Subject: Aileron actuating shaft

Affected: Sailplane model: Standard Libelle, Standard Libelle 201B, Standard Libelle 203  
All serial numbers

Reason: Cracks on aileron operating lever's welding seams due to overloading in case of derigging without disconnection of aileron controls.

Maßstab		<b>Gr. Antriebswelle</b> <b>Aileron actuating shaft</b>	<b>201-47-3</b> Techn. Mitteilung 201-33 Blatt 2/3
---------	--	--	--

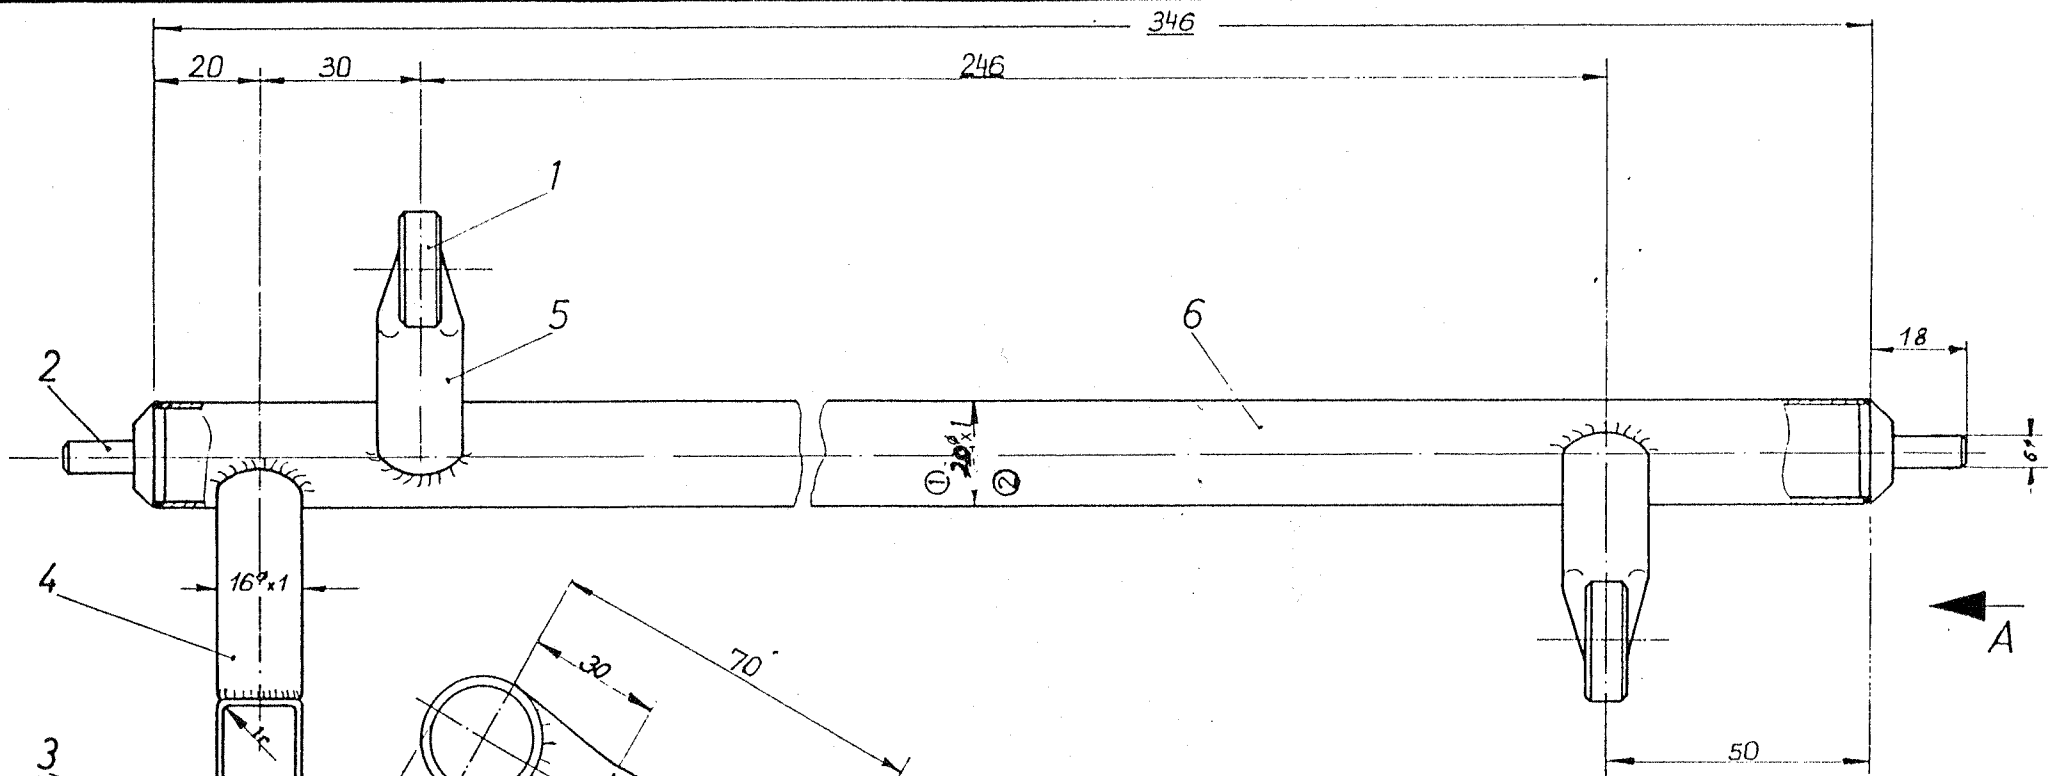
- ① Maß 20x0,75 in 20x1 ab Wnr 508 geändert 20.2.74 Unt.
- ① Dim. 20x0.75 changed into 20x1 after SN 508
- ② Maß 20x1 in 20x1,5 für Neufertigung ab 2.5.94
- ② Dim. 20x1 changed into 20x1.5 for reproduction after 2.5.94.

Method 3: If method 2 was not accomplished the original actuating shaft can be replaced by a new and reinforced shaft according to drawing no. 201-47-3, Change "2".

Pos. No.	Qty.	Part Name	Material	Part No.	Notes
11		Gr. Antriebsweile		201-47-3-1	
12		Aileron actuating shaft

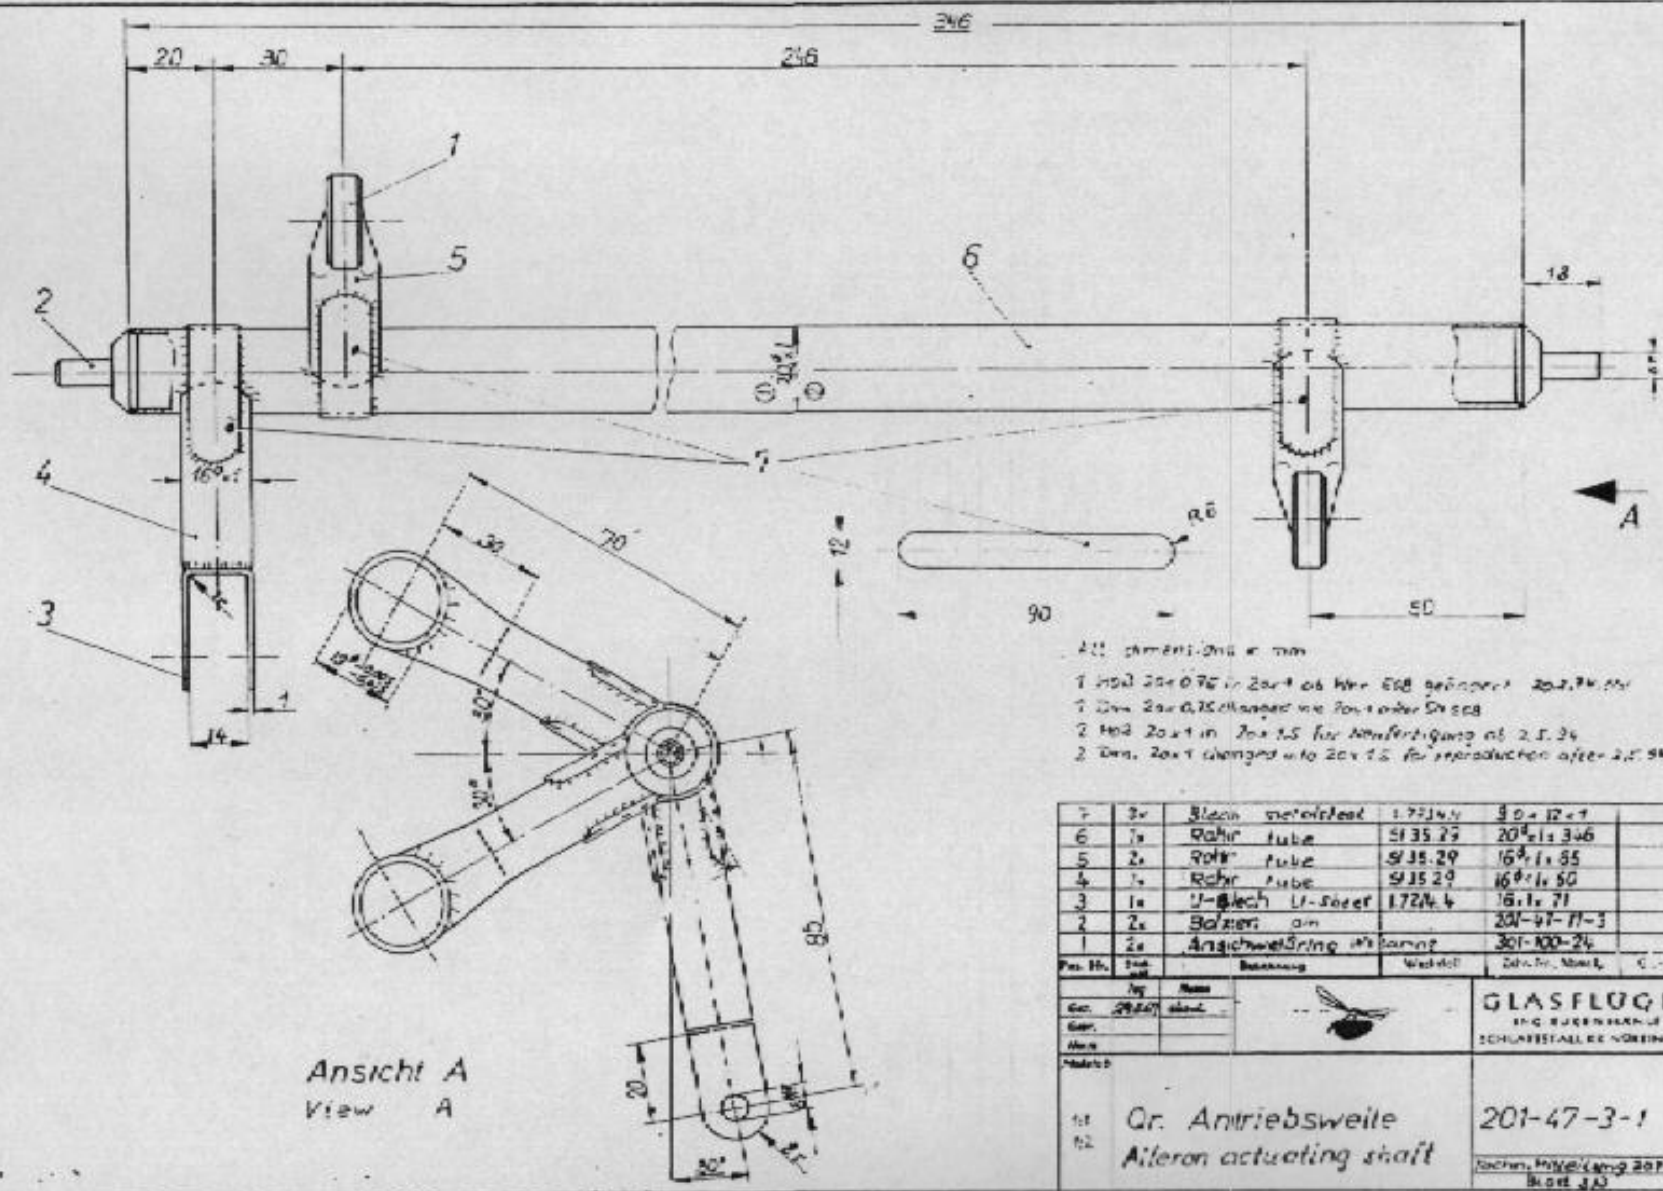
All dimensions in mm  
 1 Hölz 20x0,75 in 20x1 ab Wer 608 geändert 20.7.24. 94  
 1 Dem 20x0,75 changed in 20x1 after 21.5.24  
 2 Hölz 20x1 in 20x 1,5 for Manufaktur ab 2.5.24  
 2 Dem. 20x1 changed into 20x 1,5 for reproduction after 2.5.24.
